From: Greg Pearce [redacted] on behalf of Greg Pearce [redacted]
[redacted] <Greg.Pearce@cityofsydney.nsw.gov.au>
Sent on: November 27, 2024 12:25:02 PM
To: council@cityofsydney.nsw.gov.au
Subject: Objection to D/2017/349/A and D/2024/854, 201-217 Elizabeth Street, SYDNEY
Attachments: Submission DA-2017-349-A(GS Pearce).pdf (571.97 KB)

D/2017/349/A (SSD8105-Mod-1) and D/2024/854 (SSD64090972)

As an owner and resident of lots in Strata Plan 51487, known as Victoria Tower, 197 Castlereagh Street, Sydney, I object to the State Significant Modification application D/2017/349/A, and I also object to detailed SSDA -D/2024/854, both lodged on behalf of Charter Hall Holdings Pty Ltd, the Applicant, which are being assessed concurrently, in respect of 201-217 Elizabeth Street, Sydney.

Figure 55 Overshadowing Diagrams – 12 and 2pm 21 June

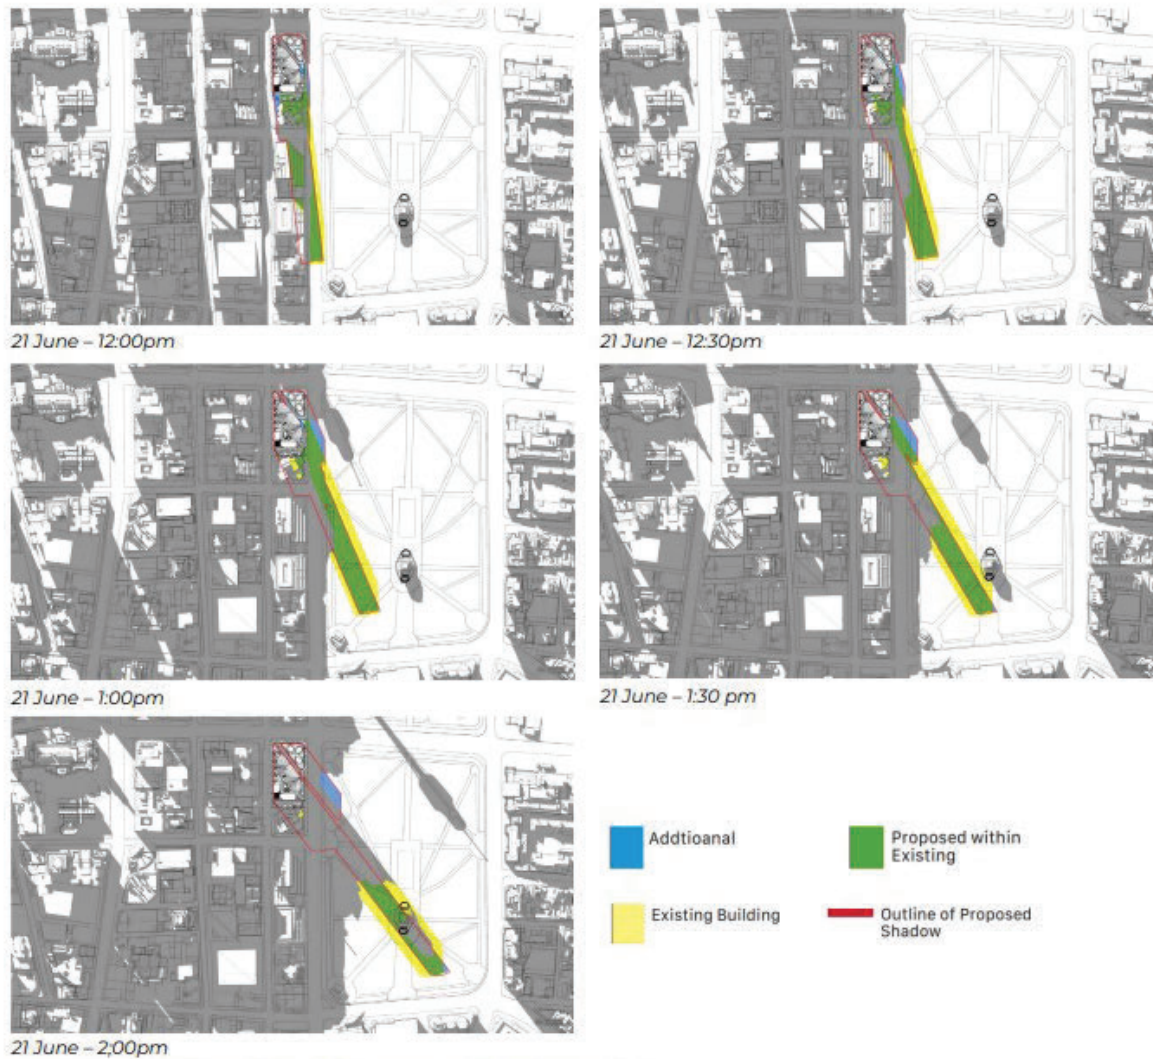
The Applicant's own shadow diagrams, Figure 55, which are reproduced below, clearly indicates significant overshadowing of Hyde Park in breach of the requirements of the Hyde Park sun access plane from 12 noon to 2 PM on 21 June (shown green). In addition, the diagrams also show new “Additional” overshadowing (shown blue) which breaches the prohibition.

The table of calculations, Table 21, establishes that the proposal would create overshadowing during the 12.00-2.00 period of 13086m², or 1.3086 hectares, during the busiest part of the day for users of the Park! The overshadowing at 13.00 to 13.30 is shown as 4,031m², a greater area than the entire site at 201-217 Castlereagh Street which is 3901m².
